BUILDING CODE OF AUSTRALIA COMPLIANCE ASSESSMENT REPORT

Proposed Independent Living Units and Community Building

3 Martin Luther Place Allambie Heights

REPORT NO. ► PROJECT 8232 - REV 01

(Ground Floor)

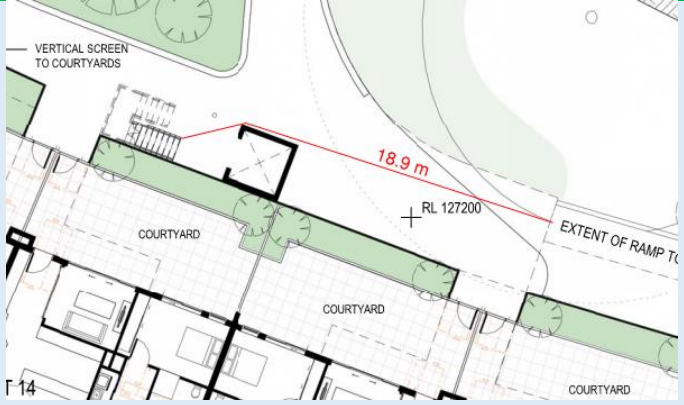
BCA DEEMED-TO-SATISFY PROVISION	COMPLIES	DOES NOT COMPLY	NA or Informational	Compliance Required	COMMENTS
					(ii) in a Class 5 or 6 building, the distance to a single exit serving a storey at the level of access to a road or open space may be increased to 30 m. (f) Assembly buildings — In a Class 9b building other than a school or early childhood centre, the distance to one of the exits may be 60 m if— (i) the path of travel from the room concerned to that exit is through another area which is a corridor, hallway, lobby, ramp or other circulation space; and (ii) the room is smoke-separated from the circulation space by construction having an FRL of not less than 60/60/60 with every doorway in that construction protected by a tight fitting, self-closing, solid-core door not less than 35 mm thick; and (iii) the maximum distance of travel does not exceed 40 m within the room and 20 m from the doorway to the room through the circulation space to the exit. Noncompliance: Building B Lower Ground floor; the travel distance from an SOU exceeds 40m to an exit (Worst case 42m from unit 12). It is recommended that the extended travel distance is addressed via a fire engineered solution.  Lower ground floor carpark: The travel distance to an exit exceeds 40m (Worst case 46m). It is recommended that a fire engineer is engaged to develop a performance based solution.  Ground floor; the travel distance from unit 24 exceeds 6m to an exit or 6m to a point of choice

BCA DEEMED-TO-SATISFY PROVISION	COMPLIES	DOES NOT COMPLY	NA or Informational	Compliance Required	COMMENTS
					(worst case 26m). In addition occupants are required to re enter the building to access a road via the lower ground floor. It is recommended that the additional egress paths and stairways are provided from the ground and lower ground levels or alternatively a fire engineer will be required to be engaged. <i>Details demonstrating compliance with this clause must be incorporated into the construction certificate plans / specification</i>
